Technical product information

Topic	New Continental GT and GTC - Rattle / Buzzing Noise - Head-Up display
Market area	Bentley: worldwide (2WBE),Hongkong-Macau (5HK)
Brand	Bentley
Transaction No.	2052431/3
Level	EH
Status	Approval
Release date

Figure 2

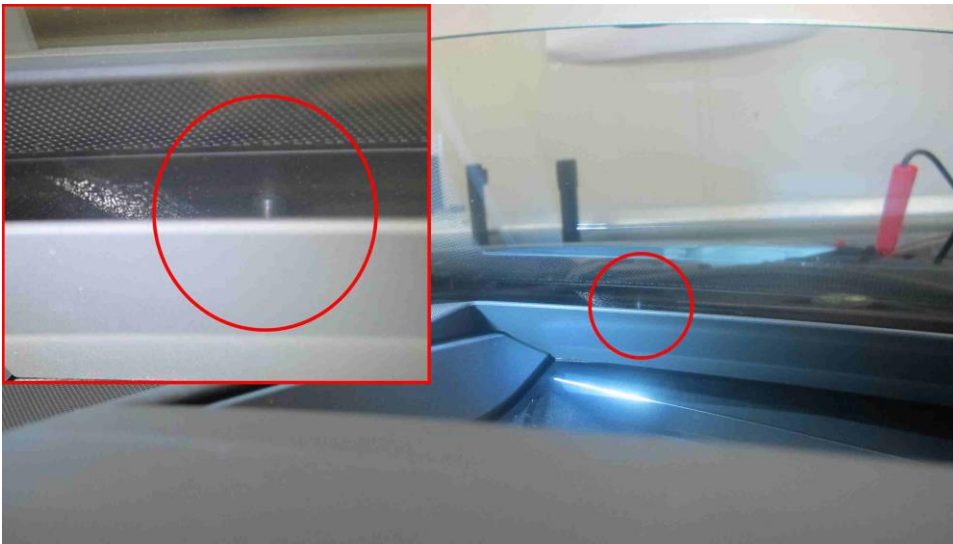
Optimised HUD (Head-Up Display) Trim Ring and Control Unit for Head-Up display.

Bump stop introduced to the dashboard at the forward area of the HUD – figure 2.

Figure 3

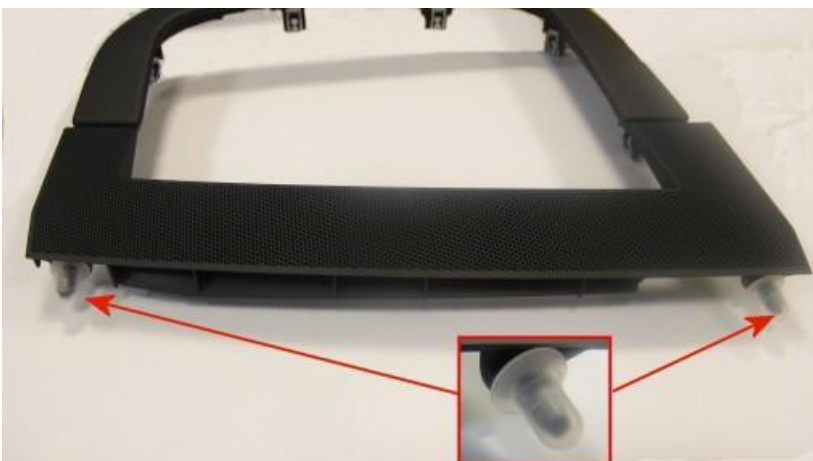
Remove the two grommets from the HUD Trim Ring – figure 3.

Figure 4

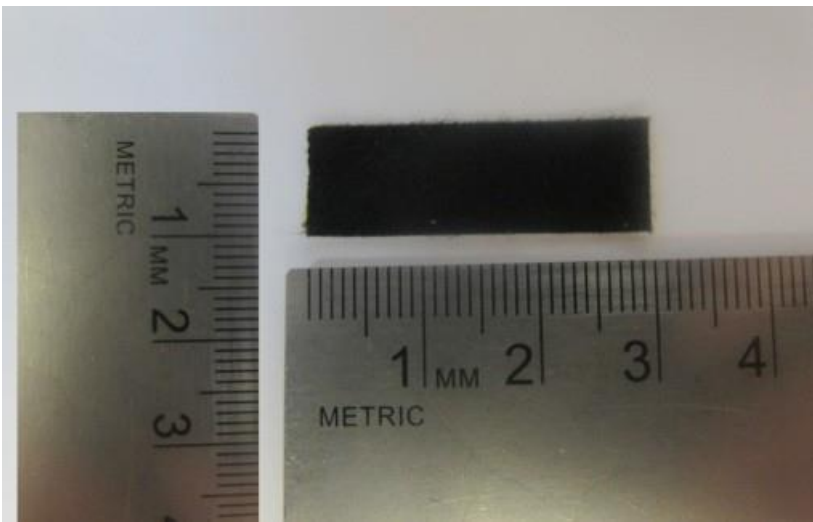
Cut two pieces of “Anti-Creak” tape to be 30mm x 10mm – figure 4.

Figure 6

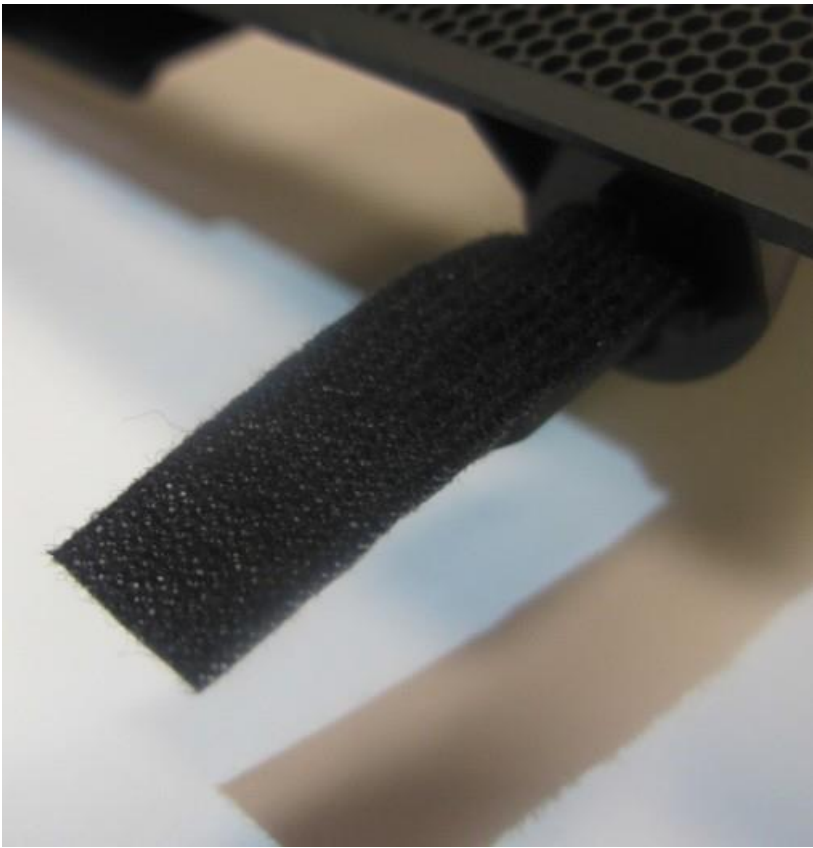
One piece of tape should be placed lengthways onto each spigot as shown – figure 6.

Figure 7

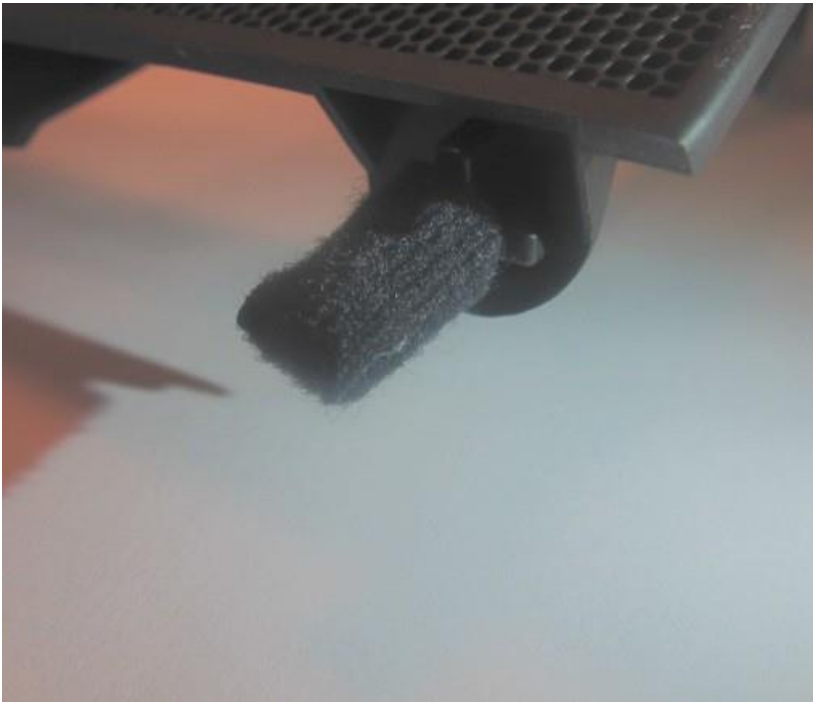
Fold the tape over ensuring each spigot is completely covered – figure 7.
